Federal Register

Monday, August 4, 2014

[Docket No. FAA-2009-1088; Directorate Identifier 2008-SW-76-AD; Amendment 39-17872; AD 2014-12-11]

Airworthiness Directives; Sikorsky Aircraft Corporation Helicopters

Figure 1-2A – Maximum Gross Weight for HEC Requiring Cat ‘A’

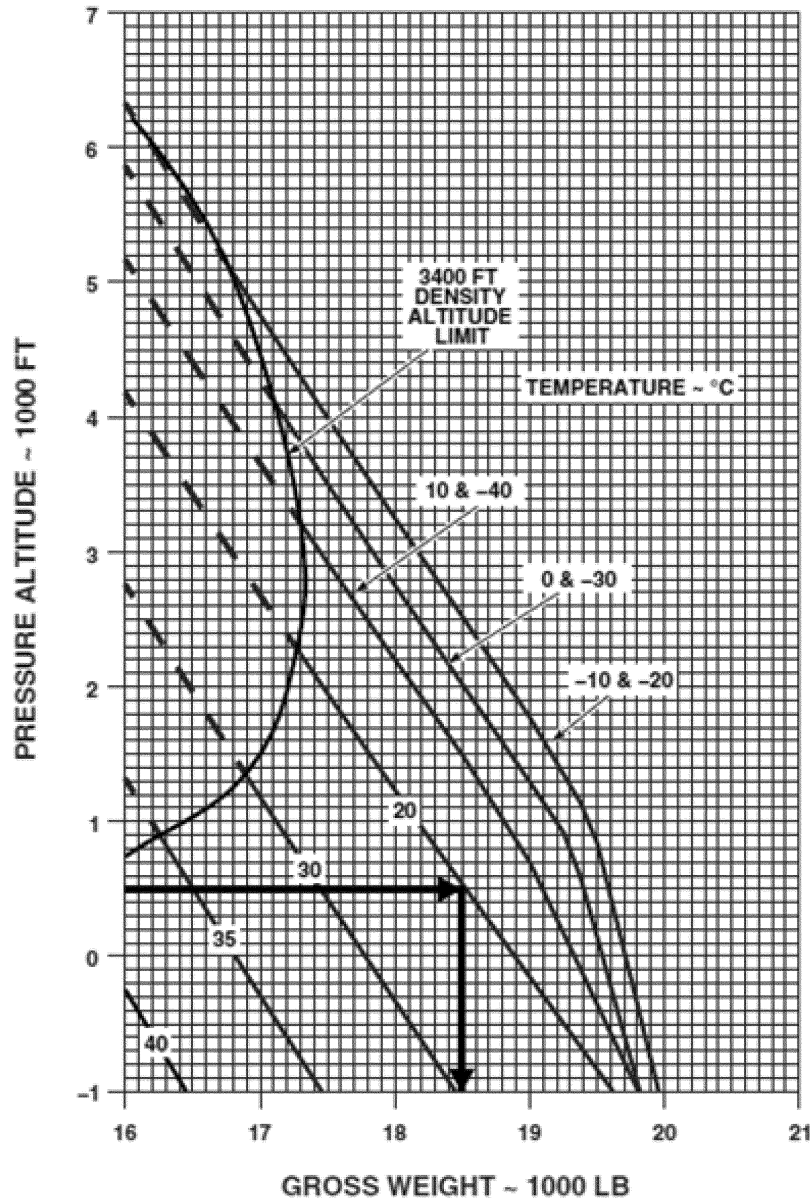
(iii) Add the following and insert Figure 1 to Paragraph (e)(3)(iii) of this AD: "HOIST" Maximum gross weight for Human External Cargo, which requires category 'A' performance capabilities, is limited to the gross weight determined in accordance with the following Figure 1 to Paragraph (e)(3)(iii) of this AD for your altitude and temperature with the air-conditioner, anti-ice, and bleed air turned off.

Note 1 to paragraph (e)(3)(iii) of this AD: Figure 1 to Paragraph (e)(3)(iii) of this AD becomes Figure 1-2A when inserted in the "Weight Limits" section of your RFM.
